IEEE 802.3 Maintenance Task Force

23 January 2024

Consideration of maintenance requests

Maintenance request 1423

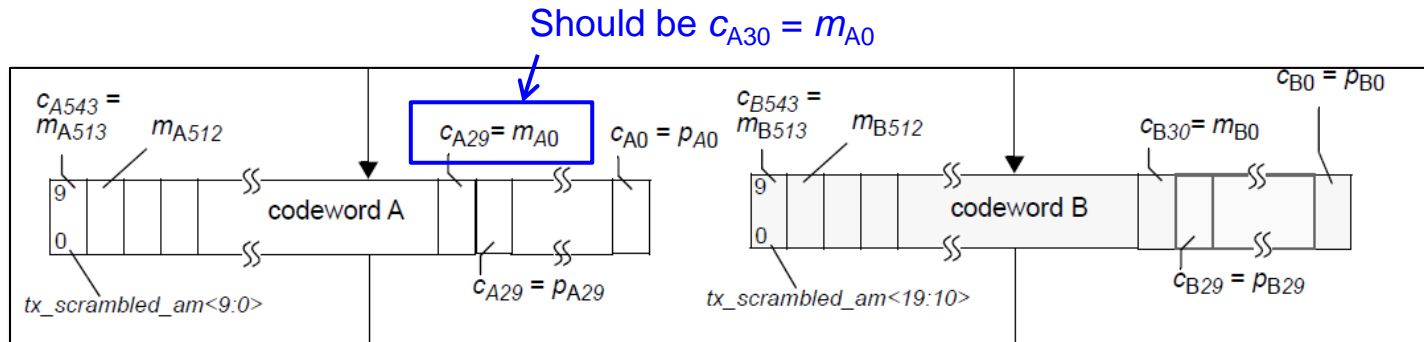
- Add the following sentence to 163.9.2.1
The connection from TP0v to the test equipment is AC-coupled.
- Add the following sentence to 163.9.2.2
The connection from the test equipment to TP5v is AC-coupled.
- Similar to statements made in similar subclauses (93.8.1.1 and 93.8.2.1 respectively)
- There is an exception for the measurement of DC common-mode voltage (see 93.8.1.3) where the test equipment makes high-impedance connection to the transmitter before the DC block
- Set status to “Ready for ballot”
